Communities Against the Tarago Incinerator (CATTI)

Formal Objection to the proposed Veolia Woodlawn
Advanced Energy Recovery Centre (ARC)

Figure 3.6, Traffic Impact Assessment, page 24.

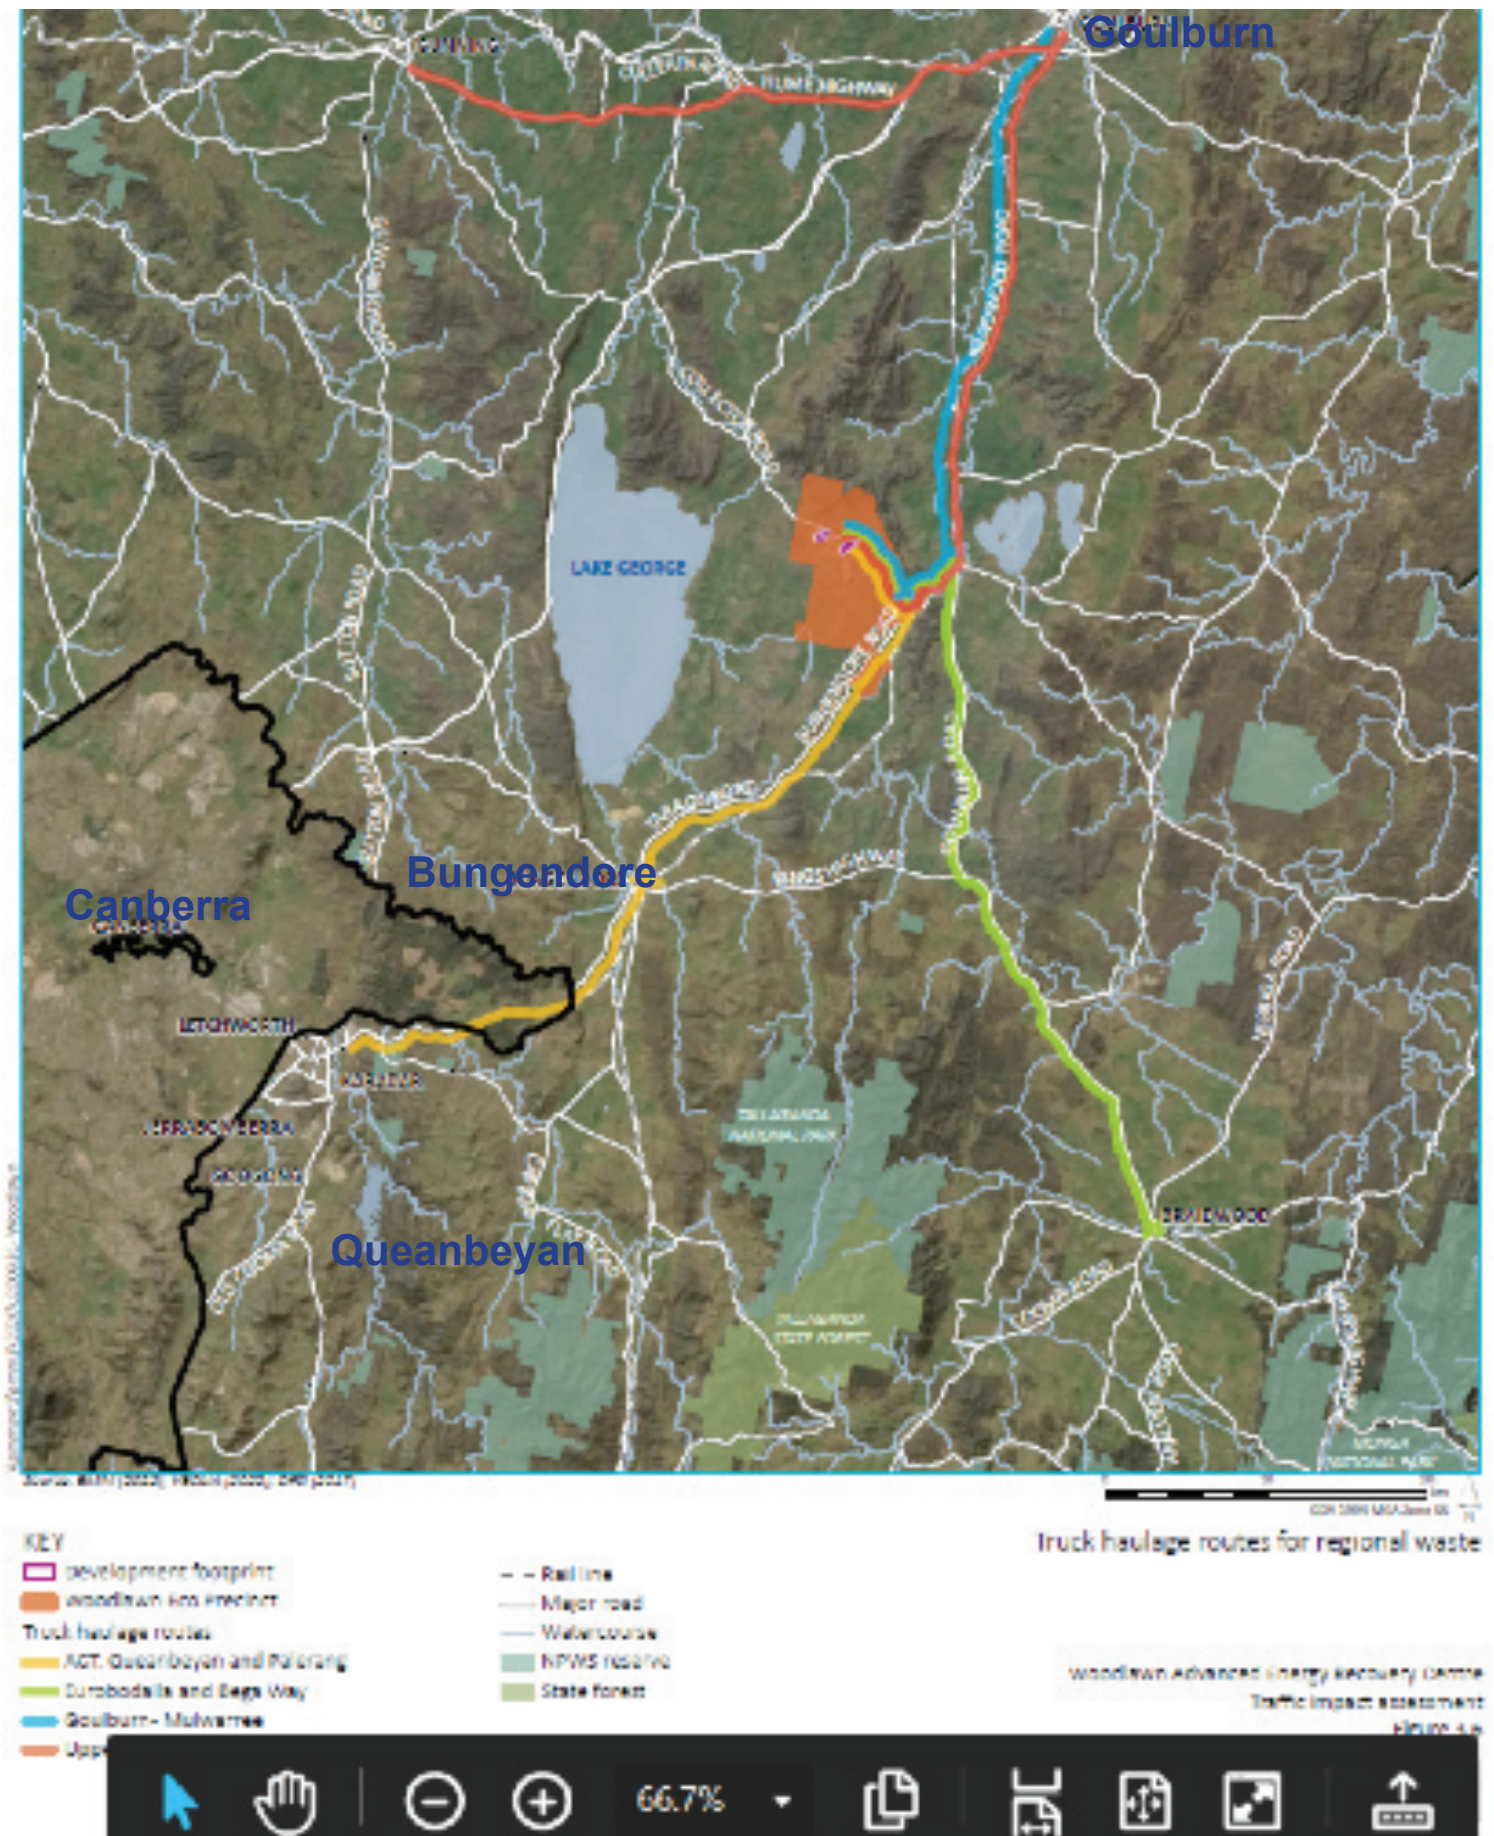
As Figure 3.6 of the traffic impact assessment (page 24) demonstrates, every truck travelling to the site travels along Tarago-Bungendore road. Trucks travelling from ACT/Queanbeyan/Palerang travel north until the Collector Road intersection, while the Eurobodalla/Bega, Goulburn-Mulwaree, Upper Lachlan and Yass Valley trucks travel through the centre of Tarago itself and then south along Tarago road and past the IMF to Collector Road.

Figure 7.1 (Appendix Y, Biodiversity Development Assessment Report, page 56)

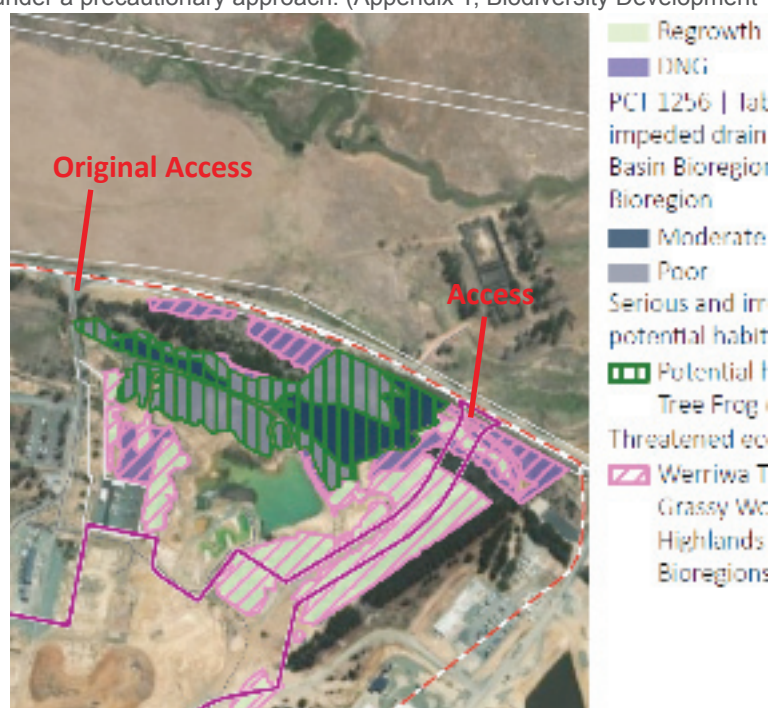
- The ARC access road was originally placed through the wetland PCT 1256, but was then redesigned so that the frog habitat is now adjacent to the subject land. The habitat appears visibly adjacent to the ARC access road in Figure 7.1 (Appendix Y, Biodiversity Development Assessment Report, page 56).

Why was a full assessment not made for this species given the proximity of habitat to the development and the report's acknowledgement that "foraging and shelter habitat" will be impacted? (Table 8.10, Biodiversity Development Assessment Report, page 90).
